**324-338 Richmond Street West - Zoning Amendment  
Application – Refusal Report**

<b>Date:</b>	December 20, 2012
<b>To:</b>	Toronto and East York Community Council
<b>From:</b>	Director, Community Planning, Toronto and East York District
<b>Wards:</b>	Ward 20 – Trinity-Spadina
<b>Reference Number:</b>	12 124056 STE 20 OZ

This report reviews and recommends refusal of the application to amend the Zoning By-law.

# Attachment 6: North Elevation

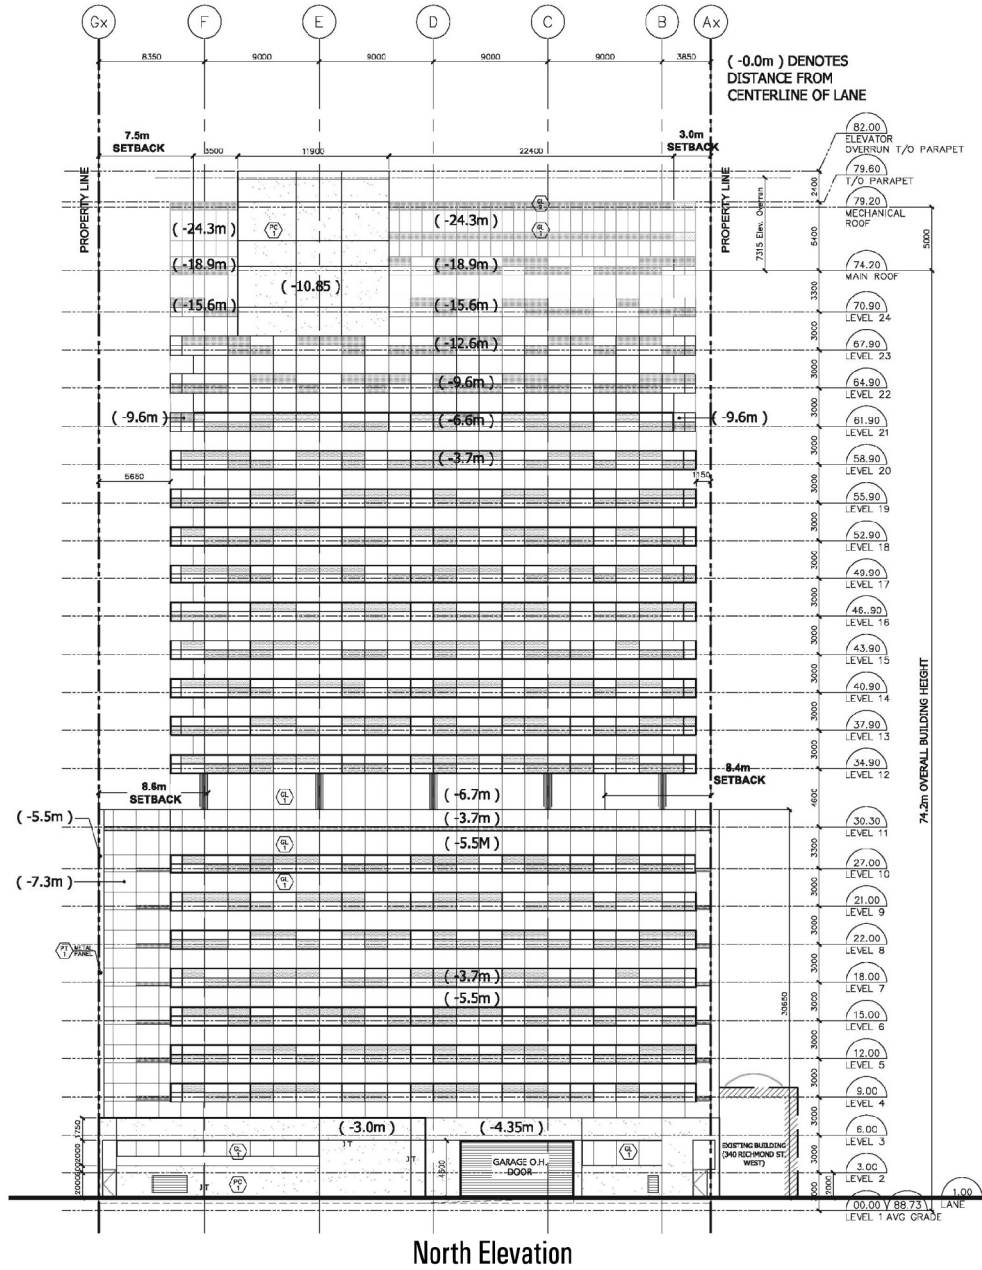
On the north elevation, there are a series of setbacks as the building increases in height. From the grade level, through to the 24th floor, the setbacks range from 3.0 to 13.7 metres. The purpose of this elevation stepping back is to mitigate shadowing on the north sidewalk of Queen Street West and to achieve a 45 degree angular plane. As discussed in the 'Sun and Shadow' content below, the built form massing requires further refinements in order to fully eliminate shadowing past the noon hour in the spring and fall equinoxes.

Given that the laneway will act as a buffer as part of the separation distance from the subject site and combined with the fact that the proposed building steps back. This reduced setback to the north is considered appropriate along the north property line.

The goal is to improve the hours of sunlight for a more desirable pedestrian condition especially through the mid-day. In addition, with the reduction in height, it is anticipated that it would also eliminate the penetration of the 45 degree angular plane that occurs on the north elevation.

## Attachment 7: South Elevation

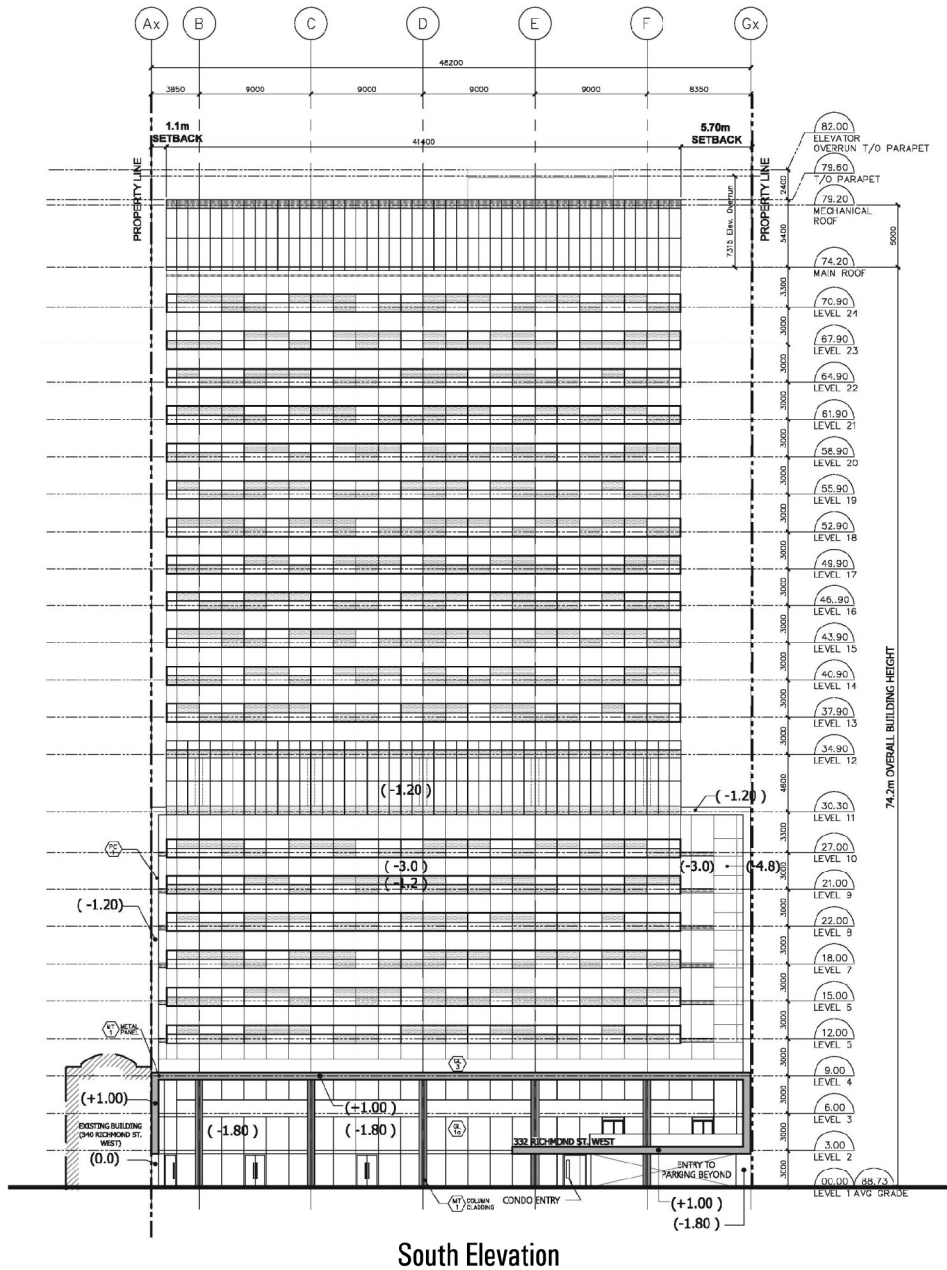
On the south side of the building, proposed is a minimal setback at grade of 1.8 metres to the property line. On levels two and three, proposed is a 1.0 metre canopy projection that encroaches into the public-right-of-way, beyond the property line. If that condition were to remain, the applicant would require a Right-of-Way Agreement.
